Addendum No. 1

(CITY OF KINGSVILLE BID NO. 24-14)
2023-2024 CITY WIDE MISCELLANEOUS CONCRETE
AND DRAINAGE IMPROVEMENT PHASE III

**2023-2024 CITY-WIDE MISCELLANEOUS CONCRETE AND
 DRAINAGE IMPROVEMENTS - PHASE 3**

**DRAINAGE FLUME BETWEEN E. LAWDALE DR. TO
 E. SEN. CARLOS TRUAN BLVD. PLAN AND PROFILE - STA 7+50 TO END**

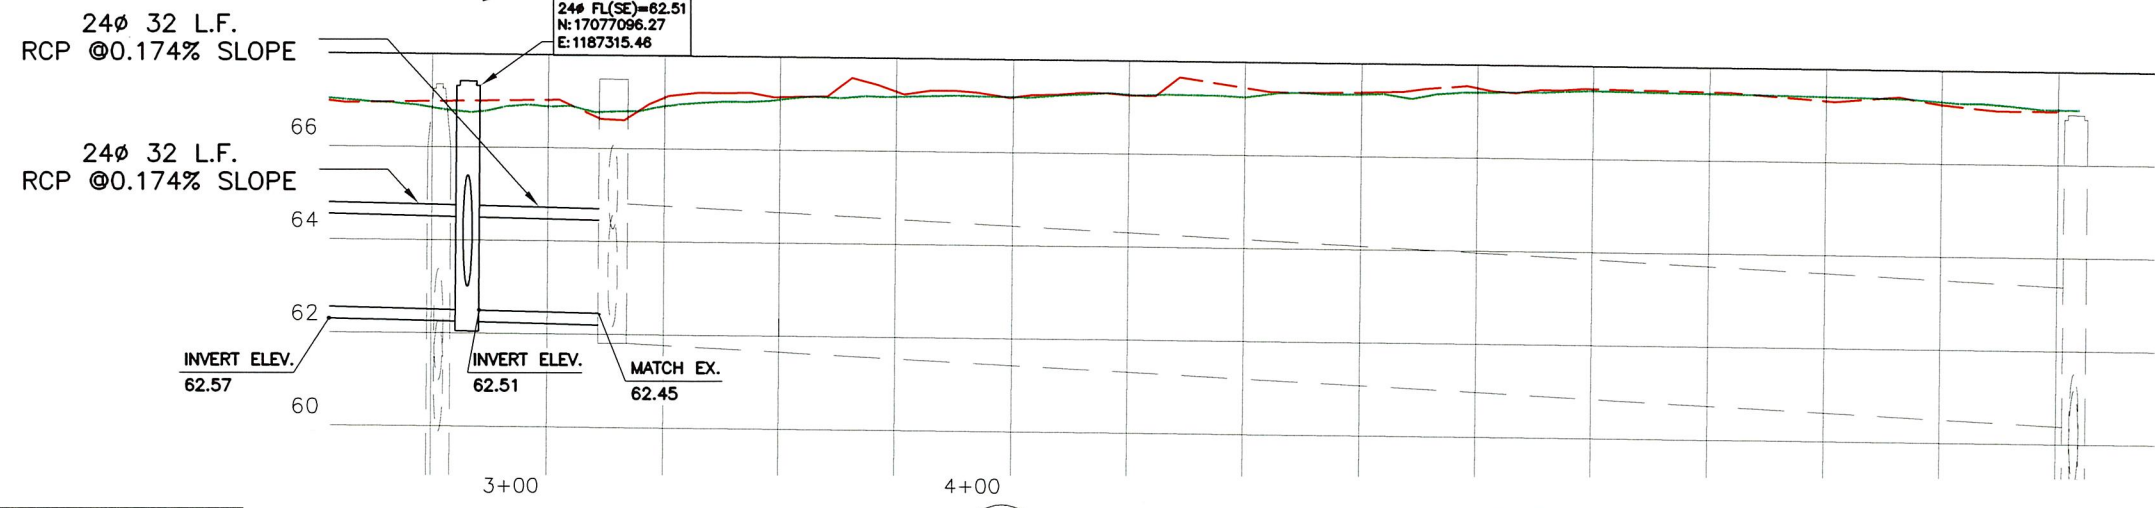
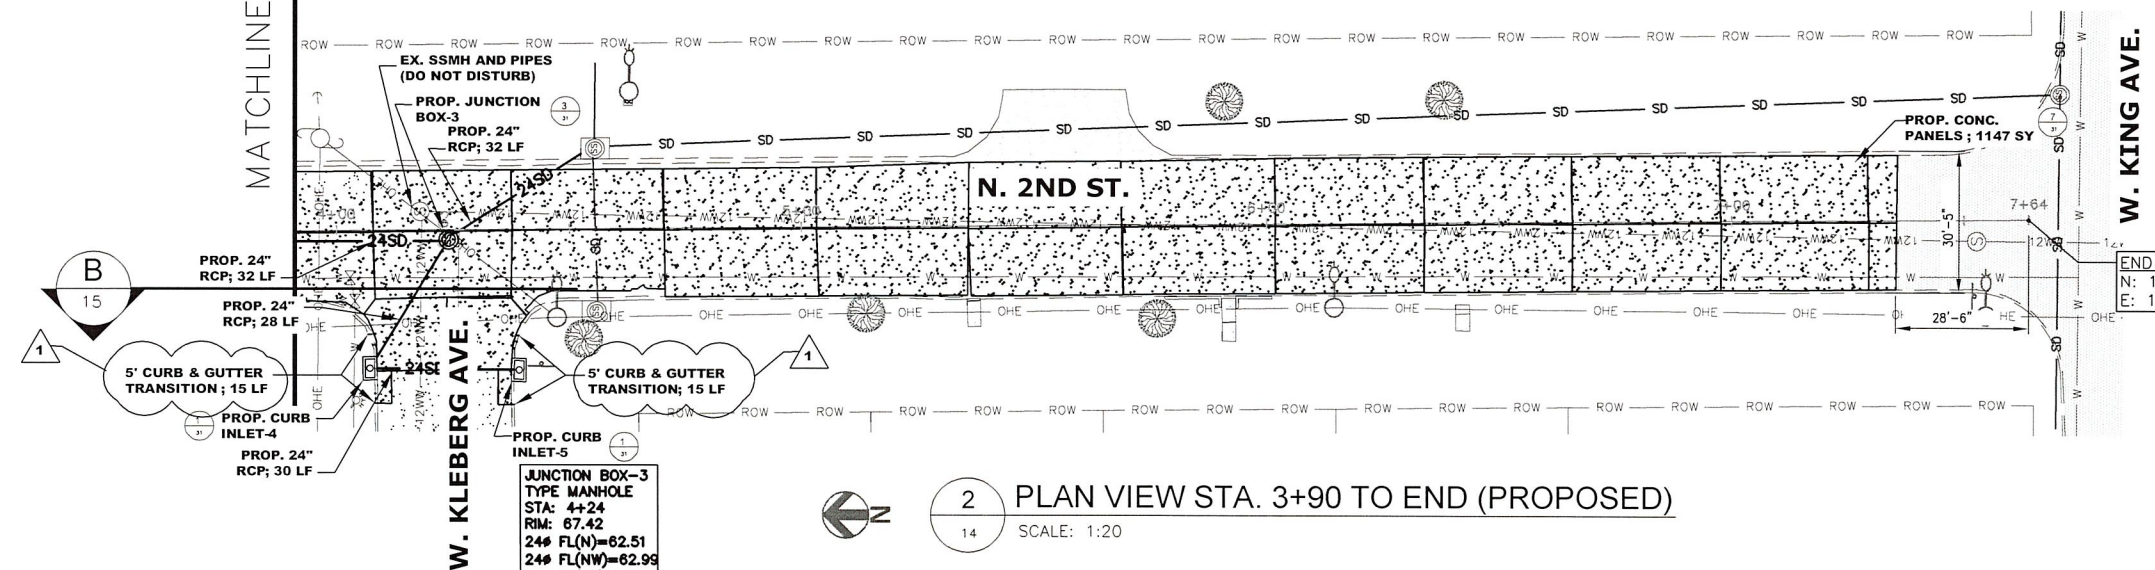
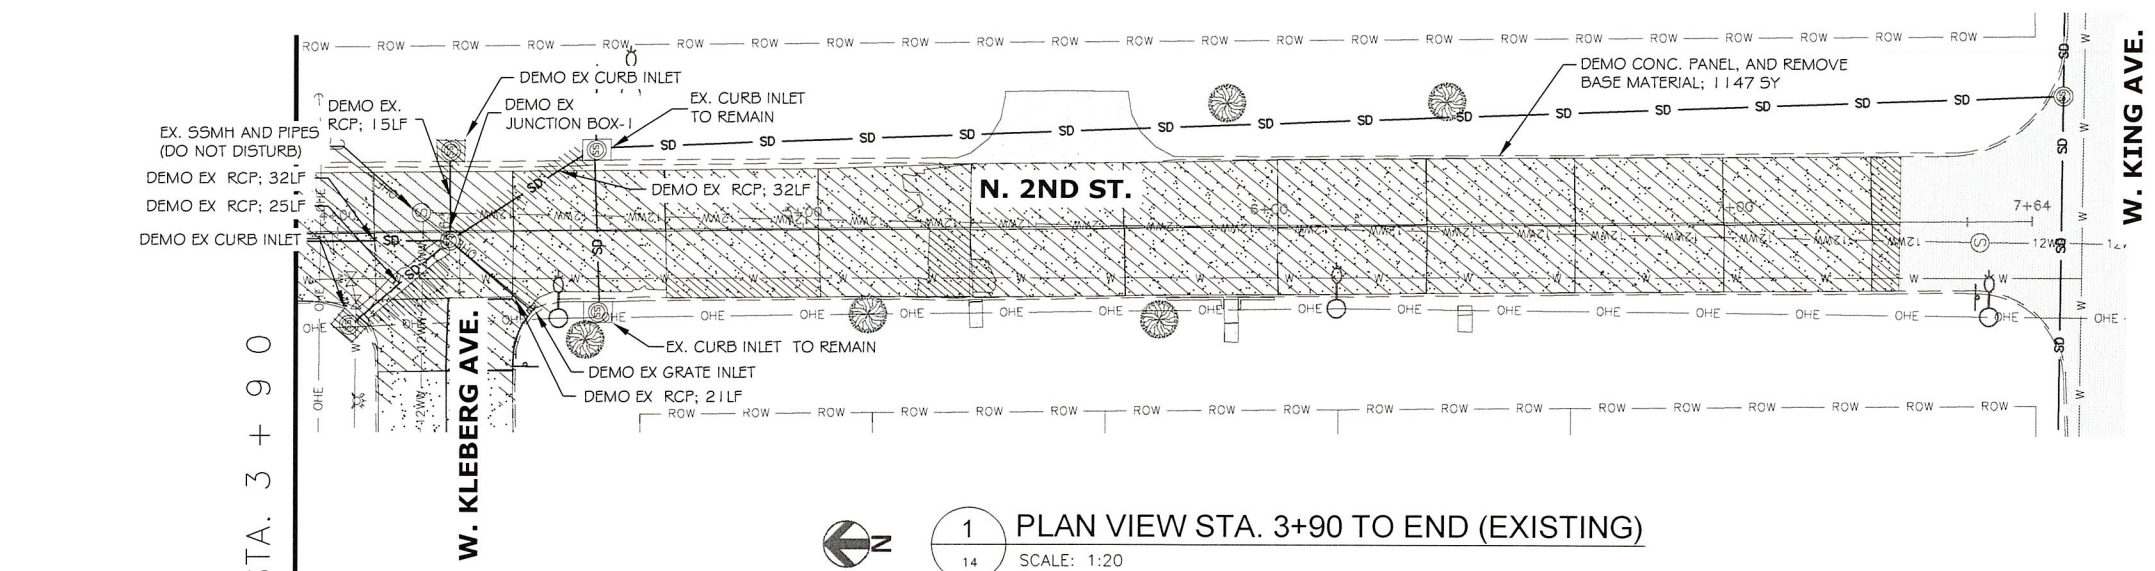
1 REMOVE VEGETATION ITEM
 ADDED & REVISED SHEET
 QUANTITIES.

8 CONCRETE FLUME

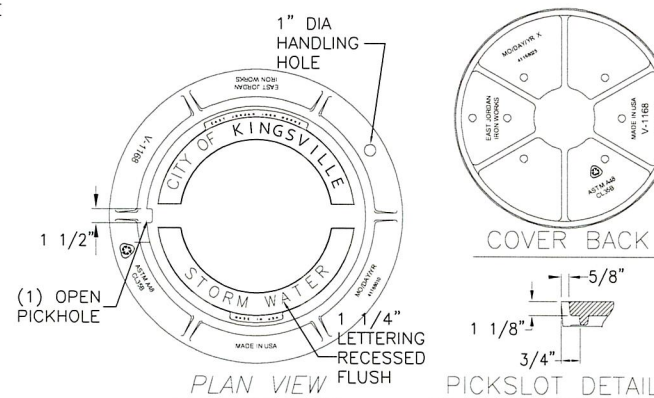
Q1: Will concrete flume require rebar and base material?

1 CONCRETE FLUME DETAIL REVISED

A1: Yes, please see attached sheet #31.
